V2500 A5/D5 SERIES PROPULSION SYSTEM SERVICE BULLETIN

This document transmits the Revision 4 of Service Bulletin V2500-ENG-72-0483.

V2500-ENG-72-0483

ENGINE – NEW FIRST STAGE DUCT SEGMENTS AND HPT VANE SUPPORT**1. Planning Information****A. Effectivity****(1) Airbus A319****Engine Models Applicable**

LOCATION OF THE STAGE 1 HIGH PRESSURE TURBINE SUPPORT ASSEMBLY
Figure 1

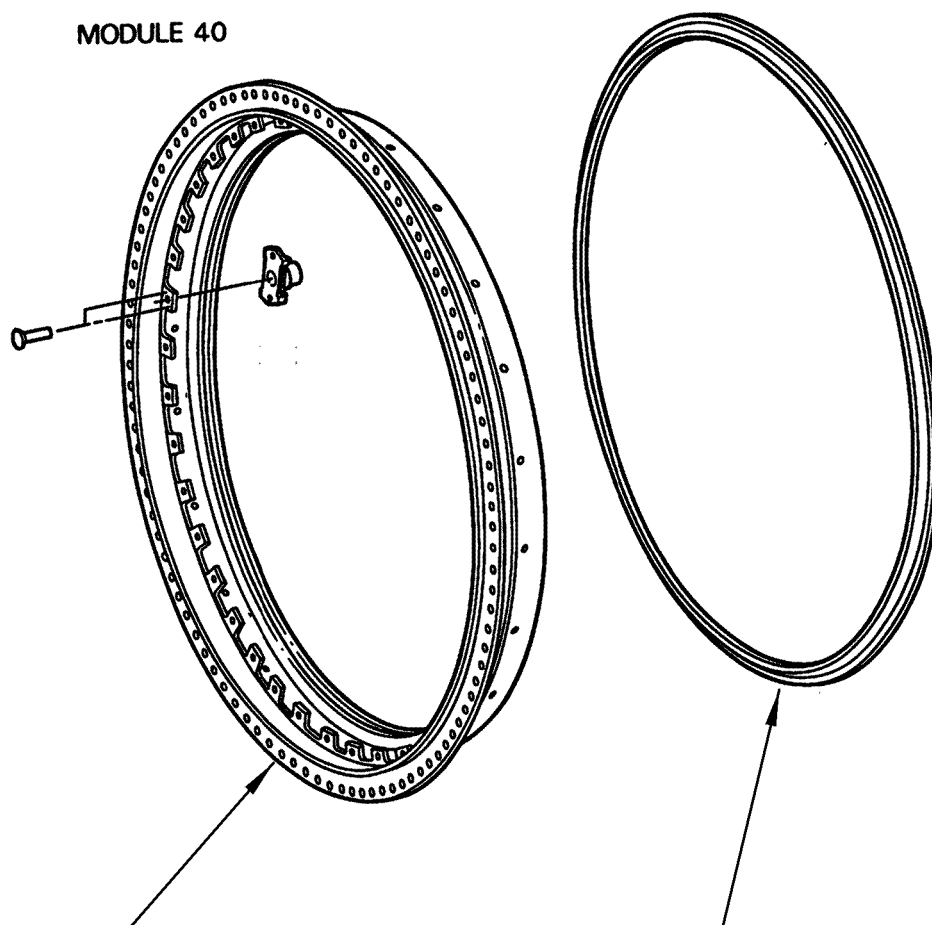
- (i) Remove the 1st stage HPT Seal PN 2A3328. See Figure 1 and 2.
- (ii) It is recommended that the Nut PN 743645 (40 off) be removed to
 avoid damage to the Nut during modification. See figure 2.

INSTALL THE 2A3896 STAGE 1
HPT SUPPORT ASSEMBLY (1OFF)

USE THE 2A3328 STAGE 1
HPT SEAL (1OFF)

MODIFICATION OF PN 2A3367 STAGE 1 HIGH PRESSURE TURBINE VANE SUPPORT ASSEMBLY
Figure 2

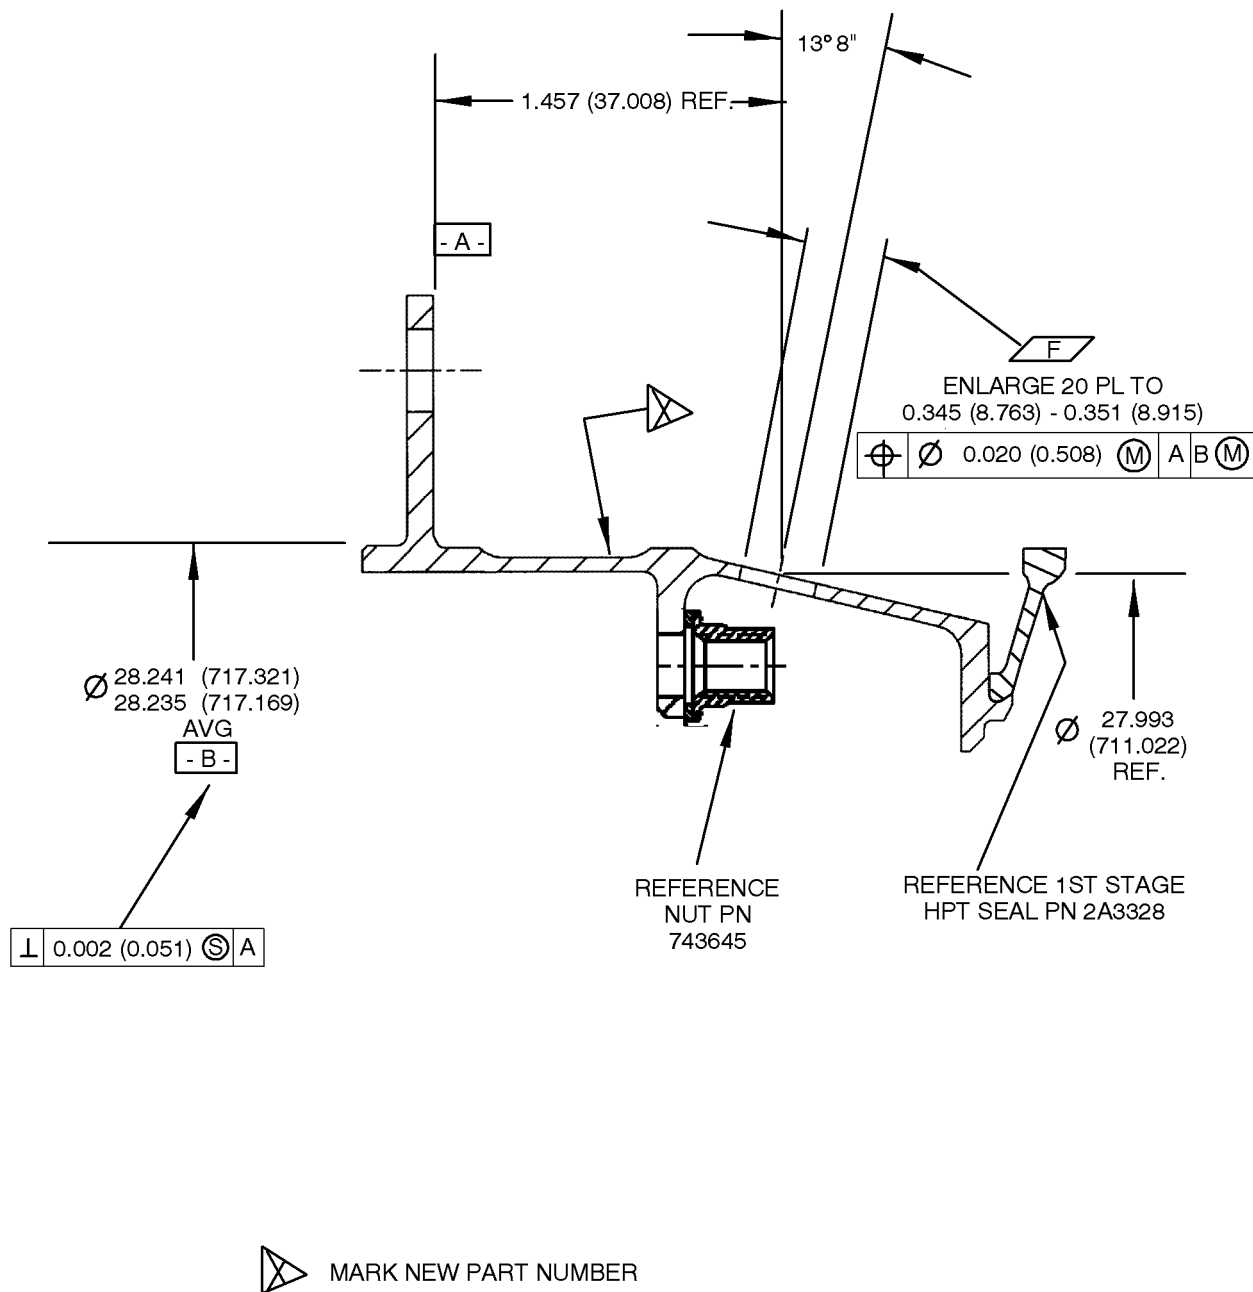
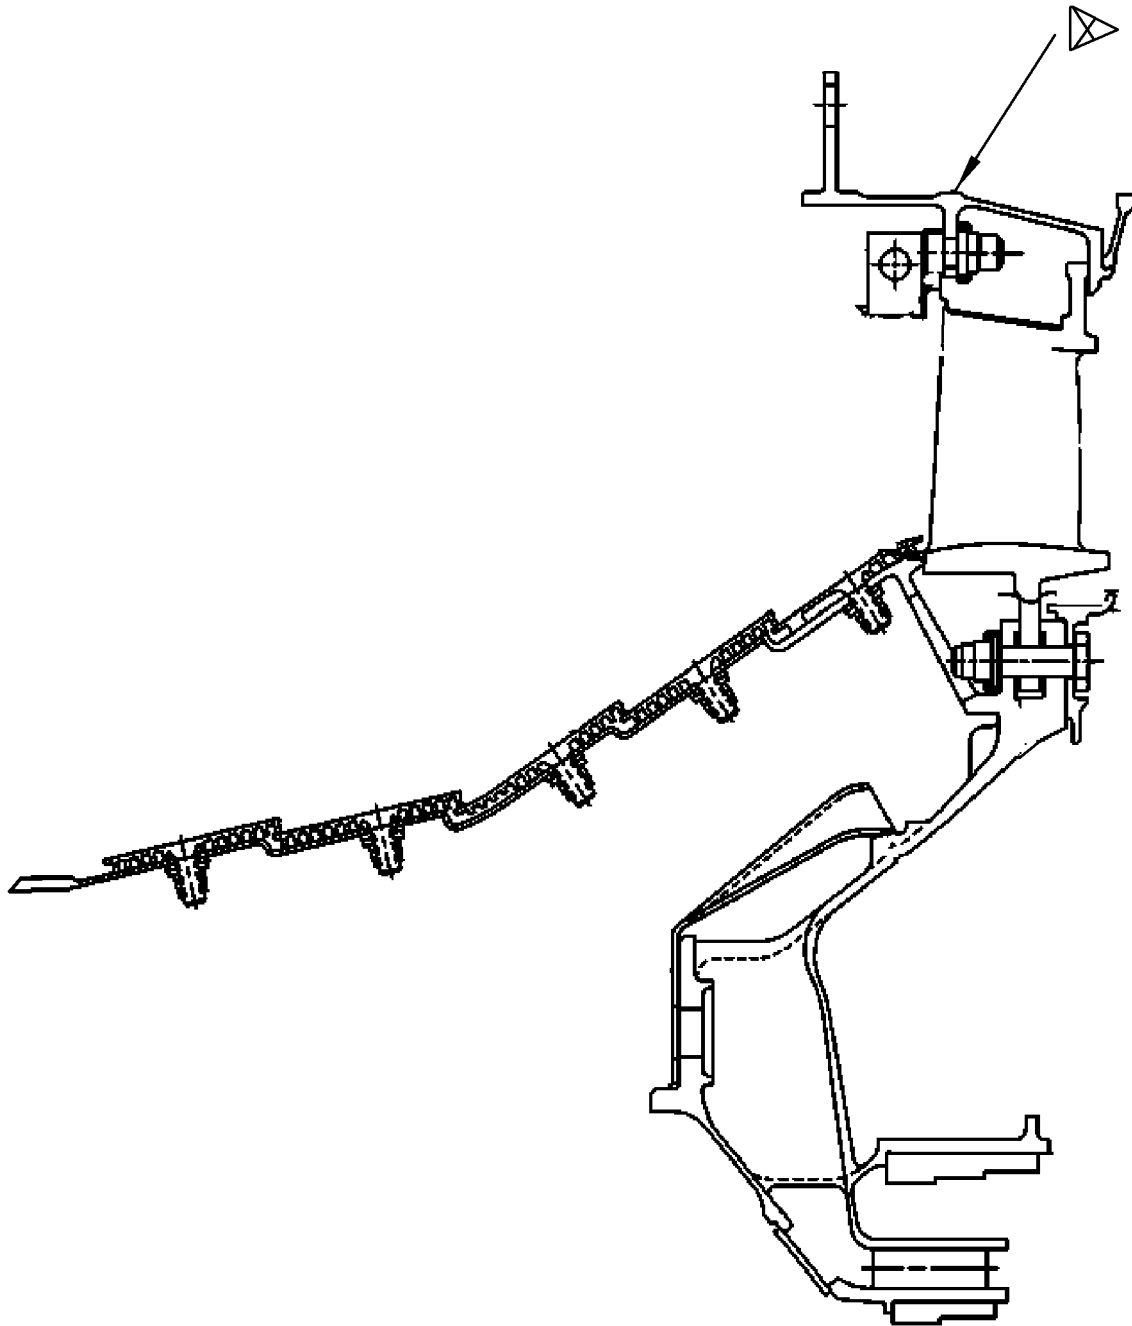
- R (a) If installed, do a modification of the 2A2703 Stage 1 HPT Vane Support
 Assembly (1 off) by incorporating V2500-ENG-72-0341.
- R (b) If installed, do a modification of the 2A3367 Stage 1 HPT Vane Support
R Assembly (1 off). See Figure 2.

- (iii) Enlarge hole 'F' 20 places in Stage 1 nonprocureable HPT Vane
 Support 2A2704. See Figure 2
- R (c) Mark the new part numbers on all affected parts. See reference (18)
 Standard Practices/Process Manual 70-09-00. Use the Deep Electro Etch,
 Metal Stamping, or Vibration Peen method.

- (i) Identify nonprocureable 1st Stage HPT Support Assembly old PN
 2A2704 as PN 2A3895 after modification. See Figure 2.
- (ii) Identify 1st Stage HPT Support Assembly old PN 2A2703 or PN
 2A3367 as PN 2A3896 after modification. See Figure 2.
